SERVICE BULLETIN

M-1350

SHIFT SHAFT SEAL UPDATE

Figure 1. Shift Shaft Seal Tool (HD-51337)

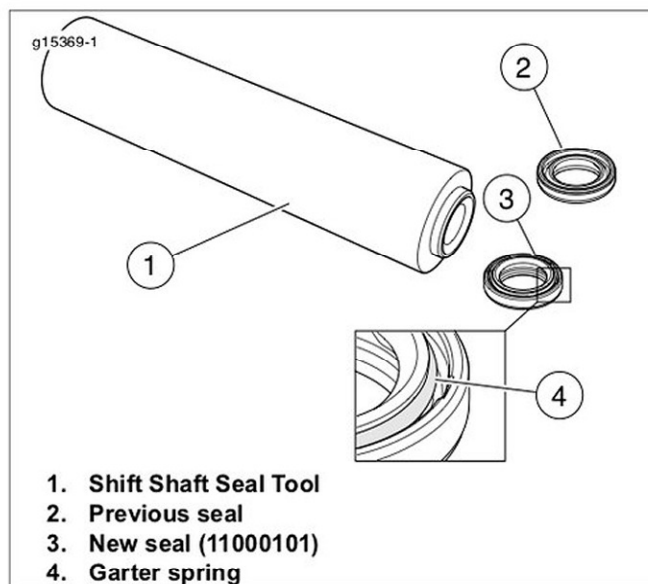
The purpose of this bulletin is to inform the dealer service network of a change to the shift shaft seal on Big Twins with six-speed transmissions. The new seal (Part No. 11000101) has a garter spring to aid in sealing of the shift shaft. The previous seal (37101-84B) did not have a spring. A new seal installation tool has also been developed.

See Figure 1. The new shift shaft seal (3) can be identified by the garter spring (4) on the back side of the seal.

1. Cover shaft splines before installing seal to prevent damage to seal.
2. See Figure 1. Obtain the shift shaft seal tool Part No. HD-51337 (1).

- Using the tool installs the seal to the correct depth.
- If tool is not used, install seal to a depth of 0.125-0.135 in (3.2-3.4 mm). Do not bottom the seal in the bore. Bottom-

ing the seal will damage it and prevent it from sealing properly.

3. Make sure the garter spring (4) side of seal faces the transmission case. Drive the seal in until the tool bottoms out on the case.
